DEVELOPMENT REVIEW BOARD REPORT

CASE NUMBER/ PROJECT NAME	81-DR-2005 New retail shops @ Fry's Center		
LOCATION	8900 E Via Linda		
REQUEST	Request approval of a site plan and elevations for two new shell retail buildings in an existing shopping center.		
OWNER	Barclay Holding XLJ LLC 480-282-4149	ENGINEER	RCC Design Group LLC 480-598-0270
ARCHITECT/ DESIGNER	A & E Solutions LLC 602-241-3335	APPLICANT/ COORDINATOR	Martin Flood A & E Solutions LLC 602-241-3335
BACKGROUND	<p>Zoning.</p> <p>The site is zoned C-3 PCD (Highway Commercial/Planned Commercial District) district, which allows for the most types of commercial activities and includes the sale of commodities or performance of service for a larger segment of population than the average neighborhood.</p> <p>Context.</p> <p>The site is located at the existing Fry's Shopping Center located at the northeast corner of Via Linda and N. 90th Street. There is an existing Fry's Supermarket on the developed site. The site has existing perimeter landscaping and the property along the southern border of the site is developed.</p> <p>Adjacent Uses:</p> <ul style="list-style-type: none">• North: R-5/PCD Multi-Family Residential, C-3/PCD Plan

SITE PLAN

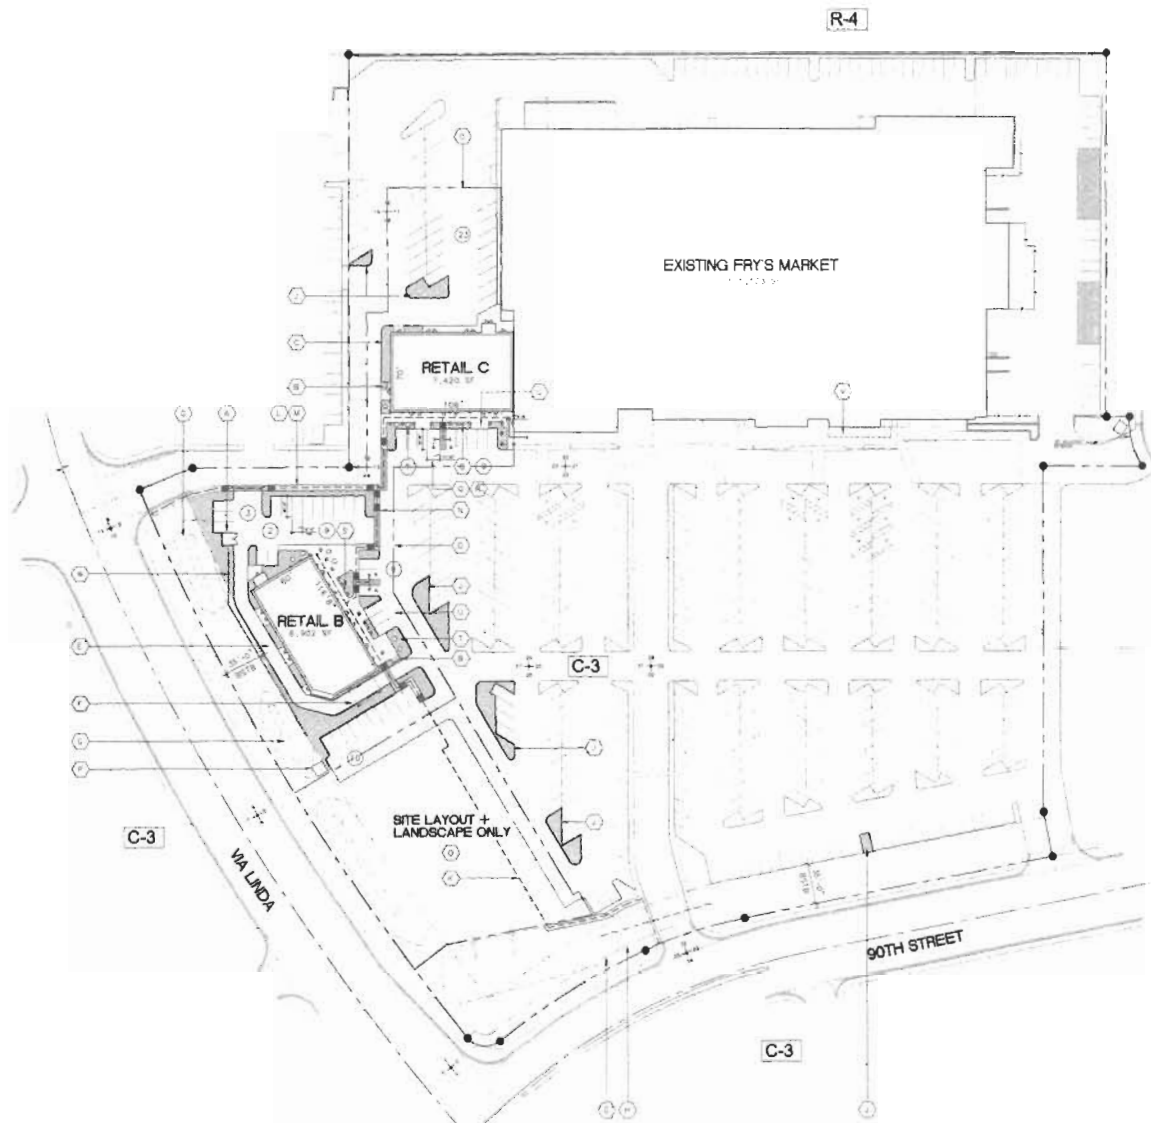
10. *The area on the site plan identified as future bank located east of Retail B shall be curbed in and landscaped with DG to match existing DG on site.*

11. *The future pad site shall be the location of a temporary nursery, if a nursery is required for this project.*
12. *The new parking areas and drive aisles along Via Linda shall be screened with a wall.*
13. *The bank proposal will return to the Development Review Board for approval of elevations and site plan.*

33. Dedicate an additional 10 feet of roadway/public access easement along 90th Street from southern driveway on 90th Street to Via Linda. City is planning to widen 90th Street to improve intersection capacity.
34. No street improvements are required for Via Linda or 90th Street.
35. No additional right of way dedication is required for Via Linda.

36. The developer shall provide a minimum parking-aisle width of 24 feet.
37. Show bike parking and standard detail.
38. Provide pedestrain connection from main retail/Retail C to Retail B. Need to include directional sidewalk ramps.
39. Provide pedestrian connection to sidewalk along main driveway onto Via Linda.
40. Provide a pedestrian opening in wall in northwest corner of site. This will provide a pedestrian connection to Camelback Walk. City will construct connection to walk.
41. The developer shall provide internal circulation that accommodates emergency and service vehicles with an outside turning radius of 45 feet and inside turning radius of 25 feet.
42. The developer shall provide a minimum of 120 feet of queuing distance for all "drive-thrus" (Bank, fast-food, etc.).

ATTACHMENT #5

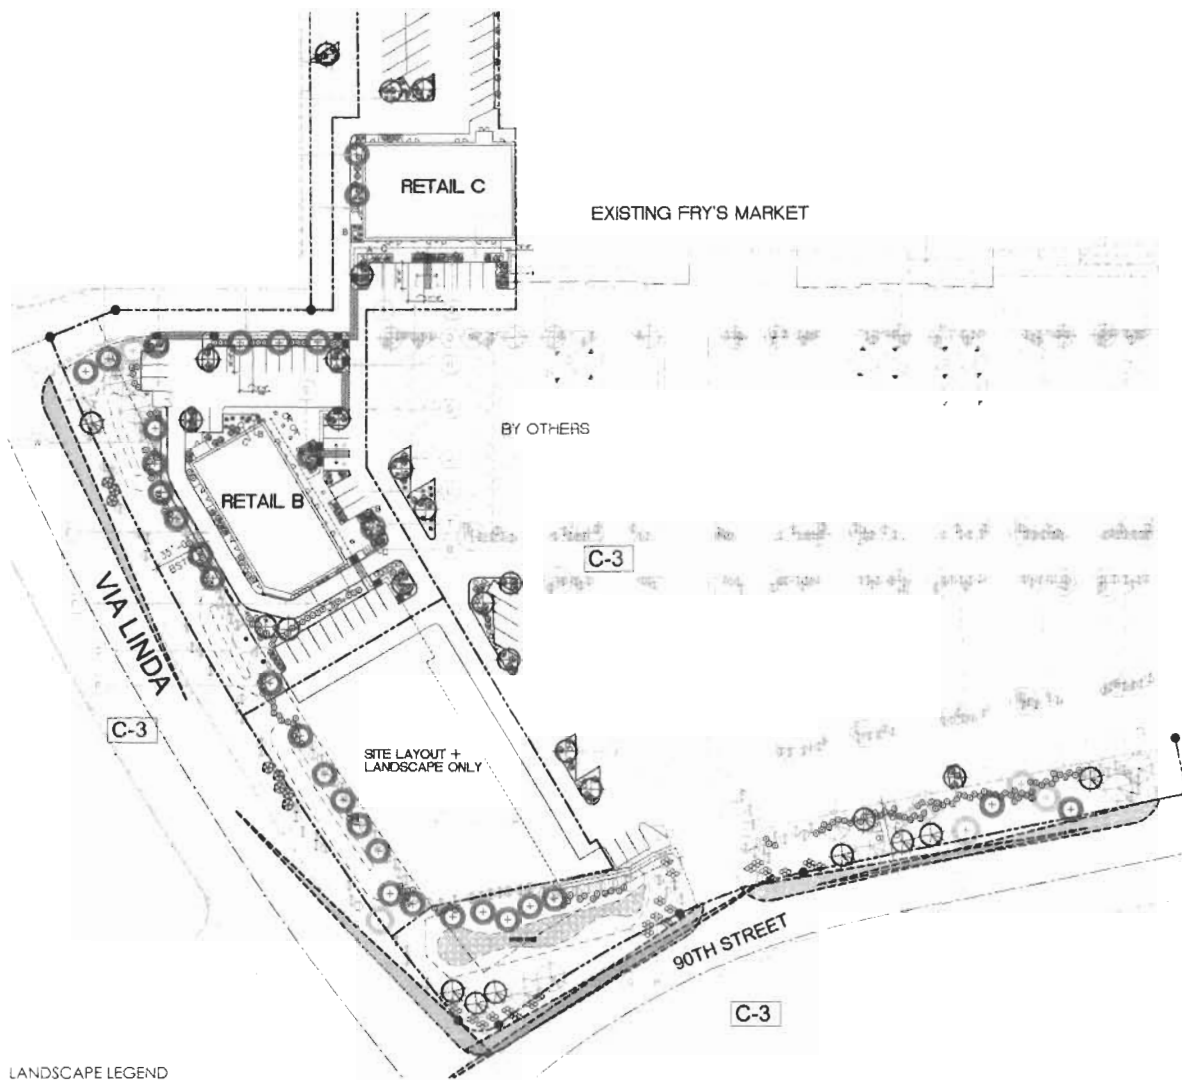
16. *Landscape proposed along the street frontage, as shown on the landscape plan, shall be installed with the construction of the Retail B building and site improvements.*

17. *Rip-rap shall be native stone.*
18. *The native stone within the frontage open space shall be buried and include vegetation within the stone to the satisfaction of the Inspection Services Staff.*

19. *Planter pots shall be a minimum of 36-inches in diameter.*
20. *The final landscape plans shall demonstrate the proposed trees do not impact the existing shrubs.*
